# TECHNICAL INFORMATION

## Finished products / Chassis concerned : TX807

**Subject : Power supply circuit**

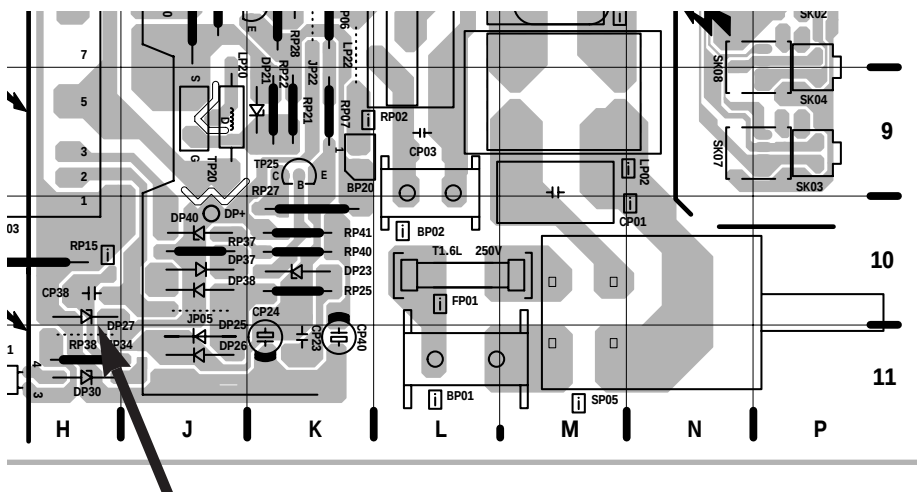
Failure of the 24-volt zener diode in position DP27 for no specific reason.

Check and if necessary change the zener diode from a BZX55C24 to a 27-volt device type number BZX55C27 parts code is **60447870**.

Comment : As a preventive measure it is recommend that this diode be replaced when the television is repaired for whatever reason.

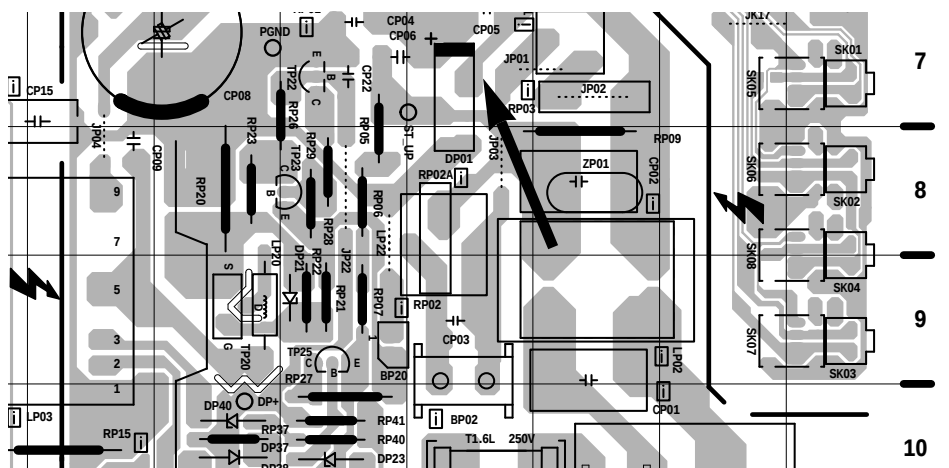
Failure of bridge rectifier RS205-K106 (600 V) at circuit reference number DP01.

Mains borne voltage spikes exceeding 600-volts

Change the bridge rectifier for a device type with a much higher breakdown voltage of type number FBI2M4S1 (1 KV) parts code is **25371810**.

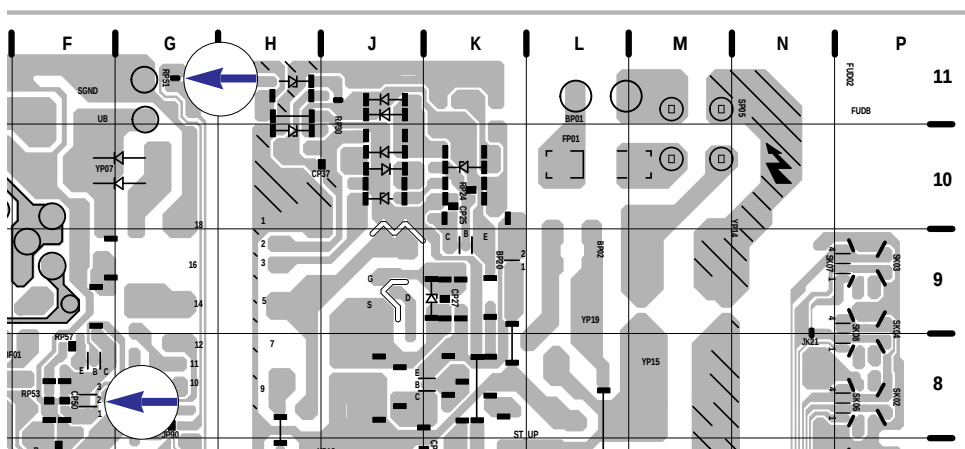
The picture being modulated by the low frequency audio components at high volume levels.

Poor regulation of the power supplies.

- Add a 4.7k $\Omega$  5% 0.10W resistor in position RP51 parts code is **60079900**.
- Change the value of capacitor CP50 from a 470pF to 220pF 10% 50V parts code is **10311200**.

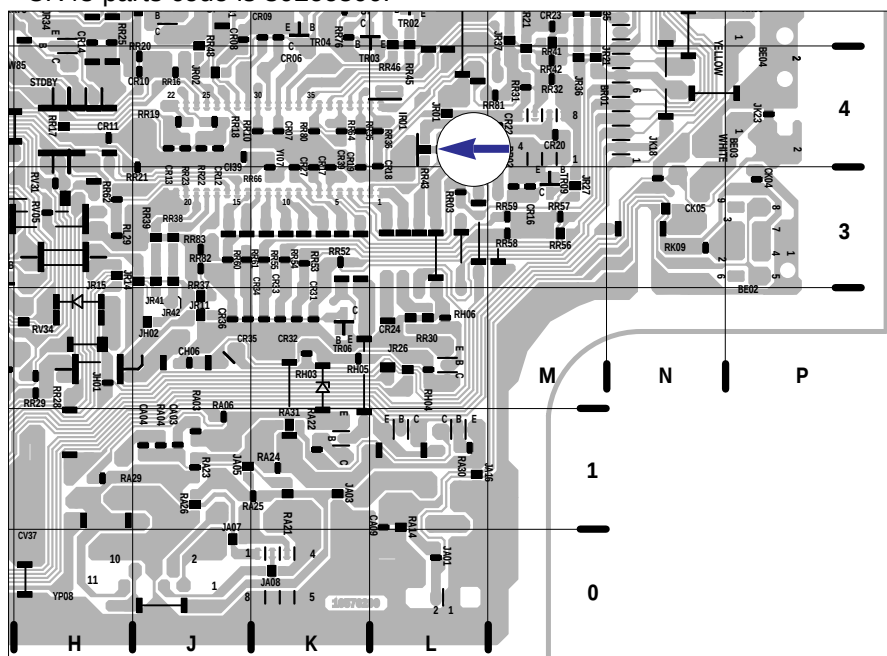
Crackling noise in stand-by (Burst mode)

- Change the value of resistor RR43 from 47kΩ to 470kΩ 5% 0.100w part code is **40077500**.
- Connect a 10nF 20% 16v capacitor between the base of transistor TP52 and ground in position CR43 parts code is **30166500**.

**Subject : Improving the stability and reliability of +5VR supply voltage to the Tuner/Teletext Module.**

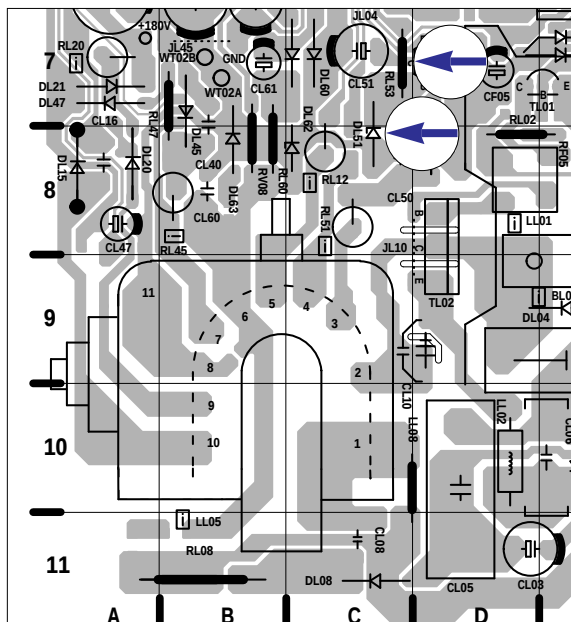
To improve the stability of the base drive current of transistor TL50 please change the following :

- the zener diode at circuit location DL51 from a 1N5233B 6V to a BZX55B 5V6  
parts code is **70438200**.
- the value of resistor RL53 from 820Ω to 390Ω 5% 0.250W parts code is **15007960**.
